REPLACEMENT FOR L780S09 REGULATOR IN AR3000A MAIN UNIT

IF PCB IC11を變更

L780S09 (VOLTAGE REGULATOR WITH STROBE)

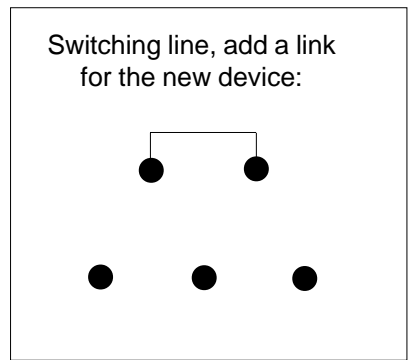
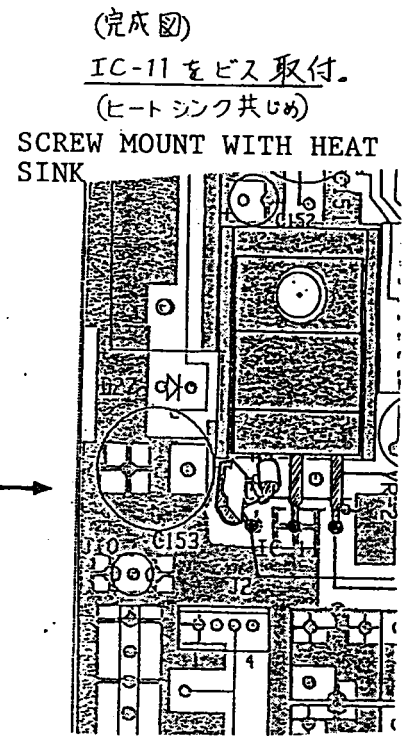
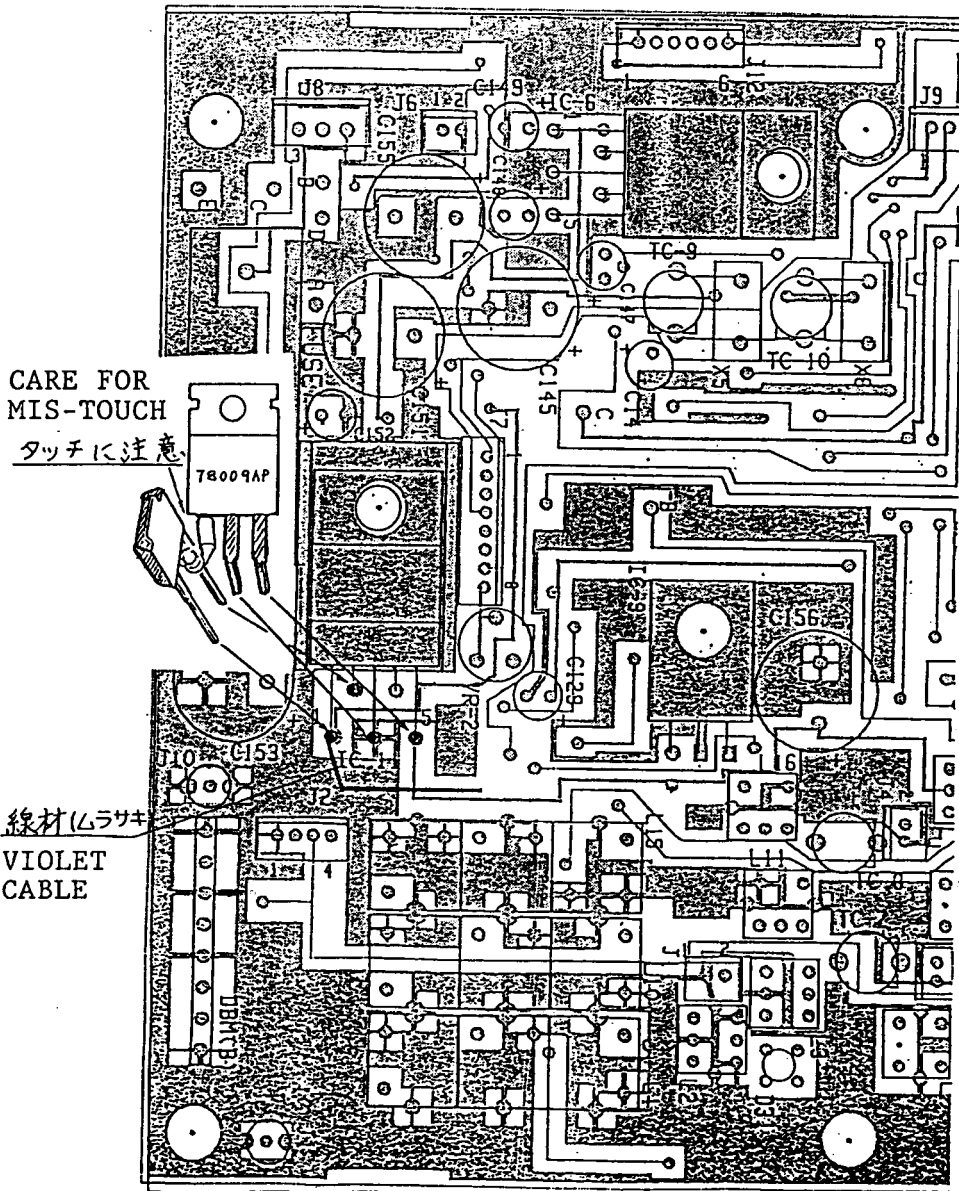
The original voltage regulator with strobe is no-longer available (L780S09). As a substitute, another regulator 78009AP is employed with a FET J325 used to switch it (strobe).

The original regulator used 5 connection holes to the PCB, the new 'combination' arrangement uses a total of 4 holes, however you need to add a link for the switching line of the regulator - add a shorting link with between the PCB pads (would have been between pin-2 & pin-4 of the original device, see above).
